## **ADDENDUM NO. 2**

Date: May 23, 2018

**Project: Hiram Johnson HVAC Replacement**

**E3.21**

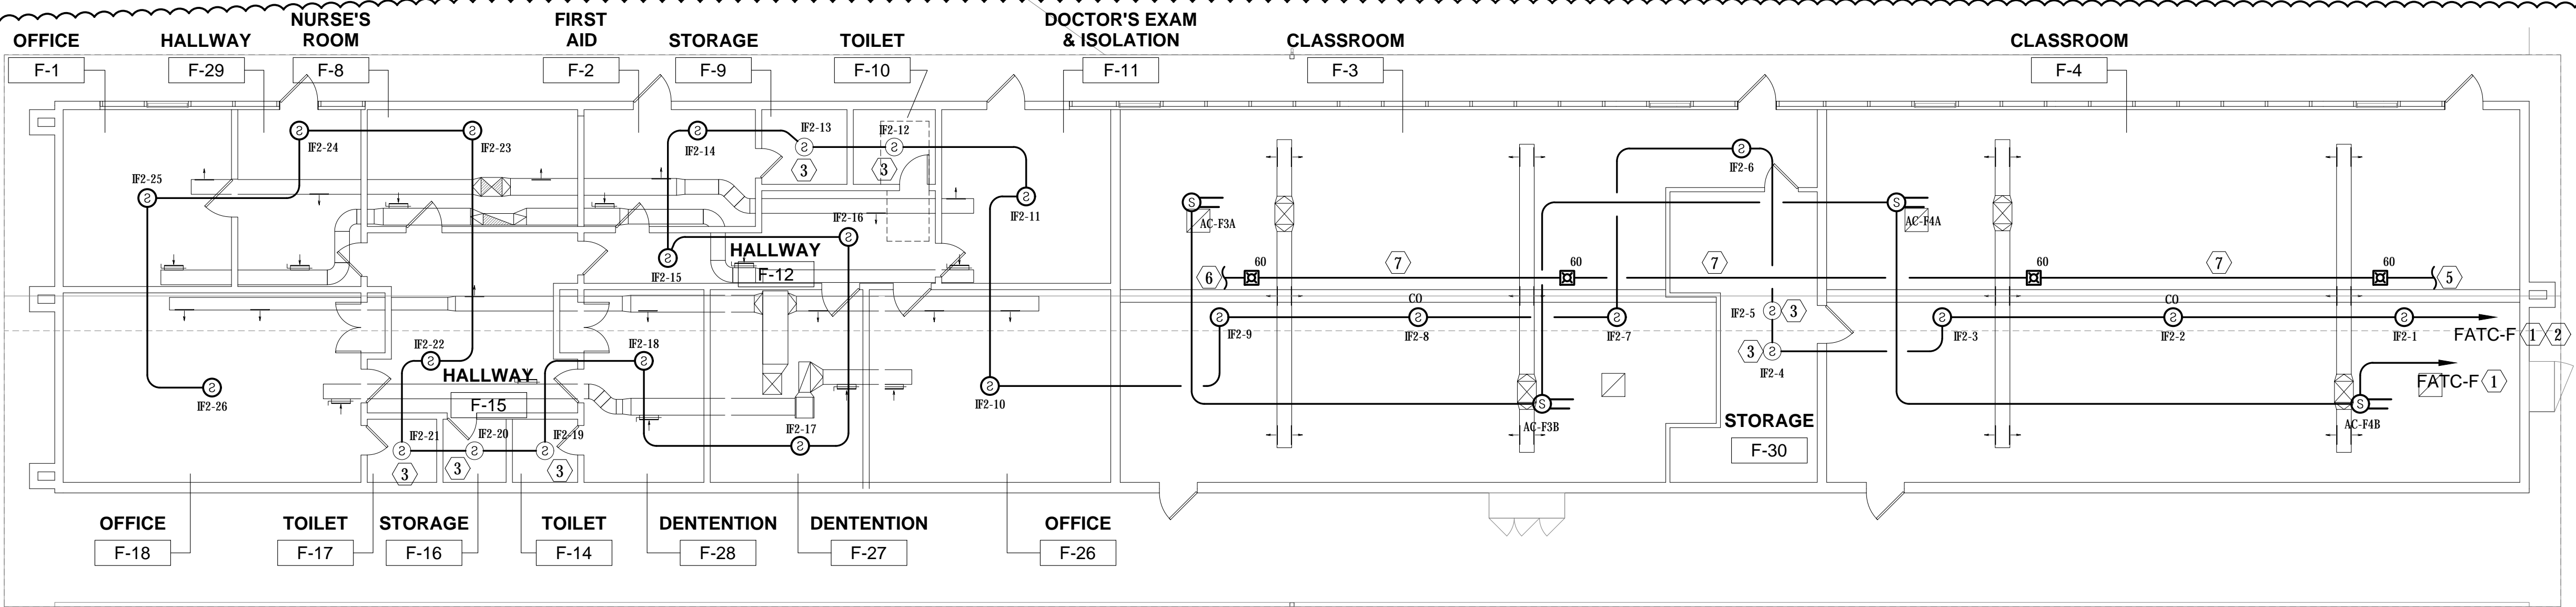
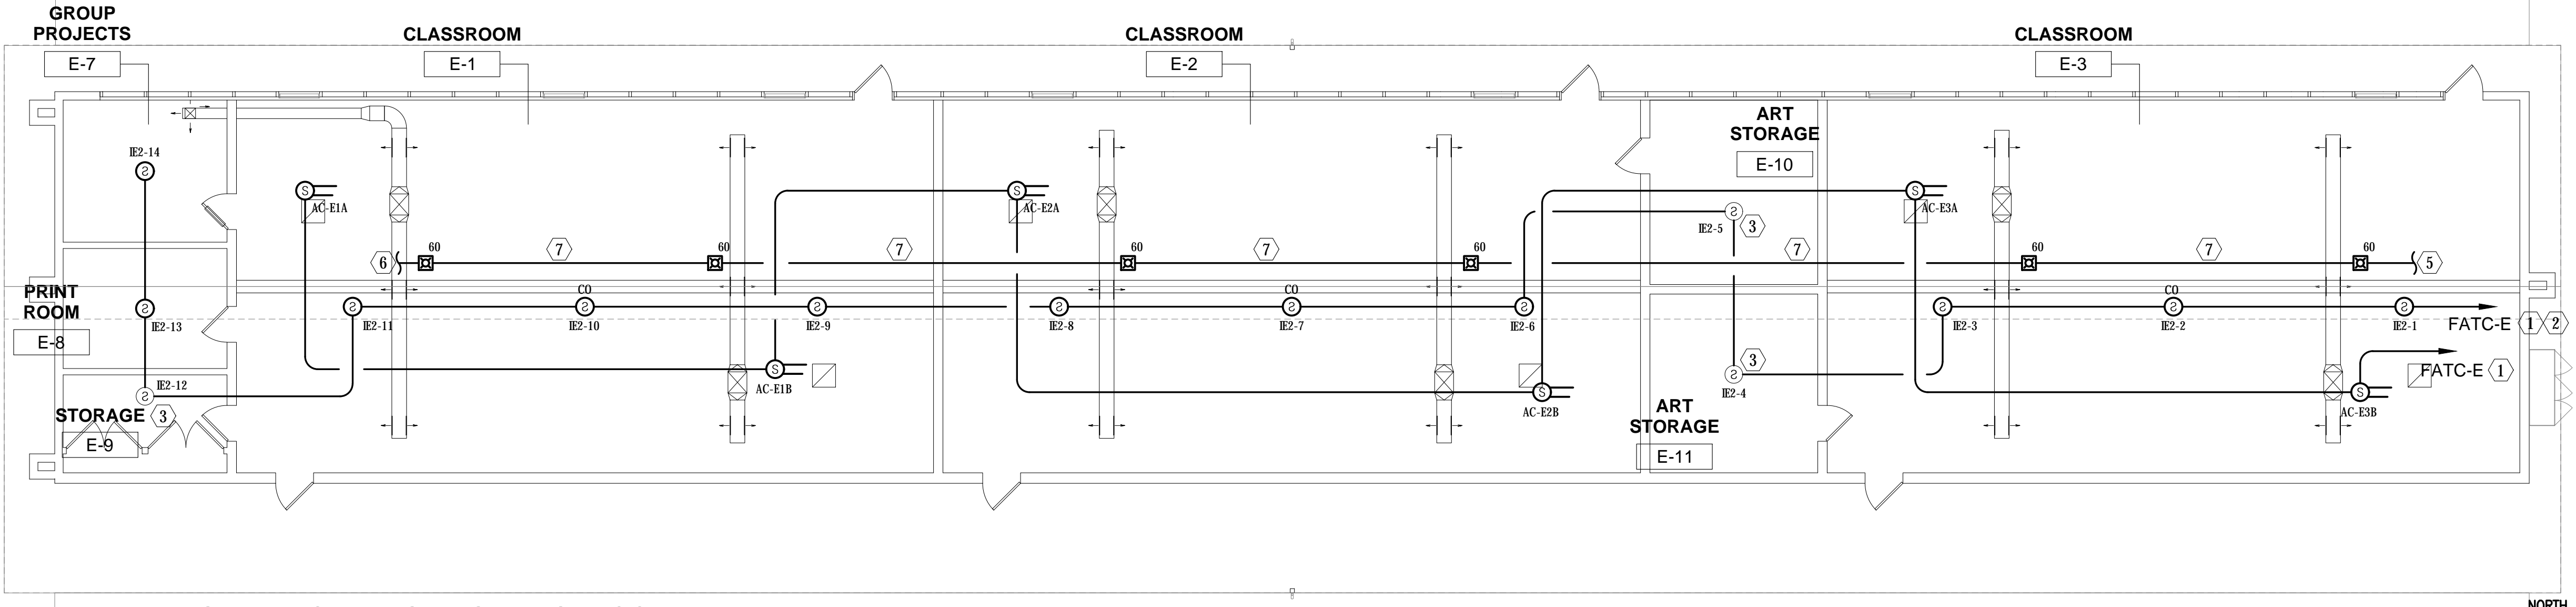
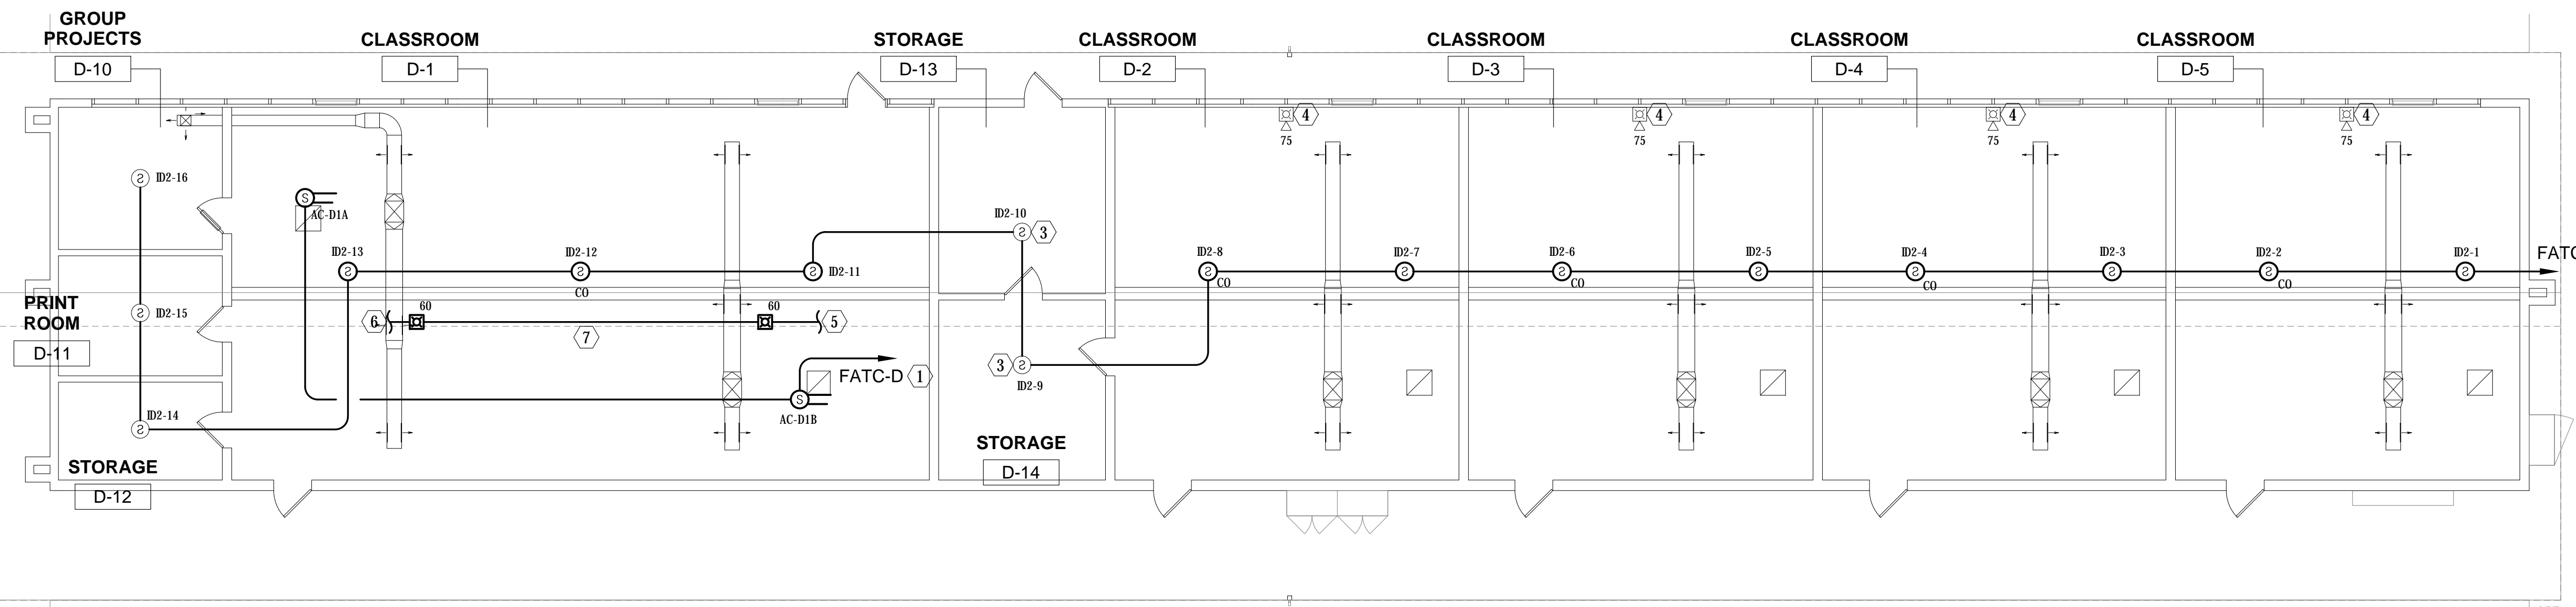
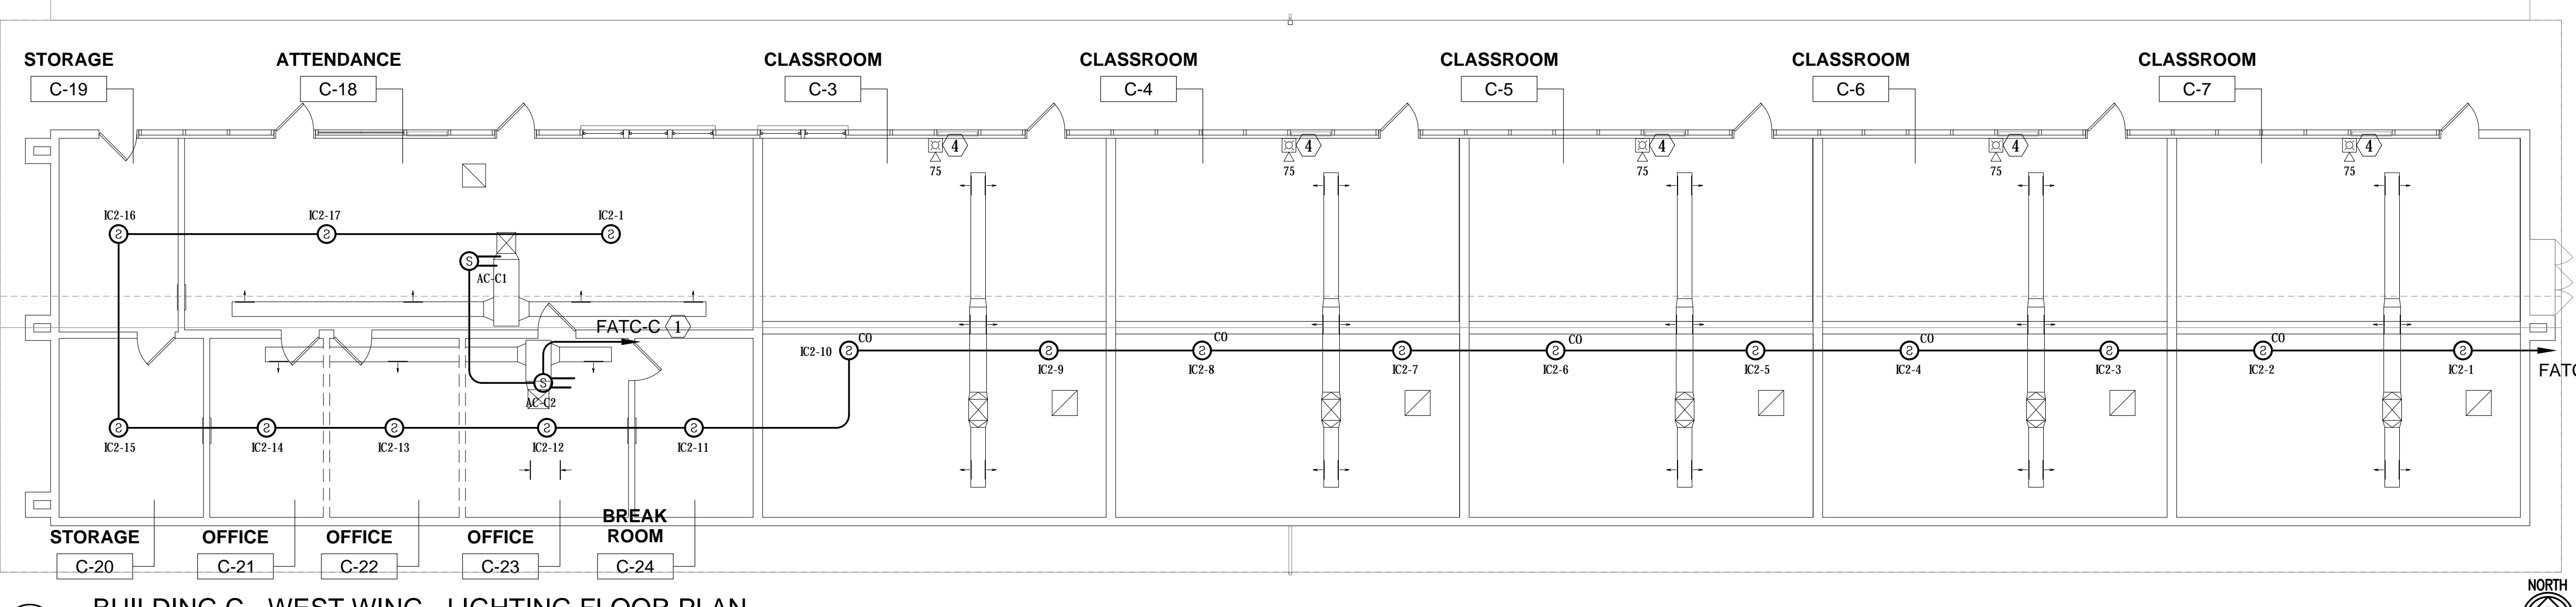
**Refer to Drawing Sheet E3.2.1**
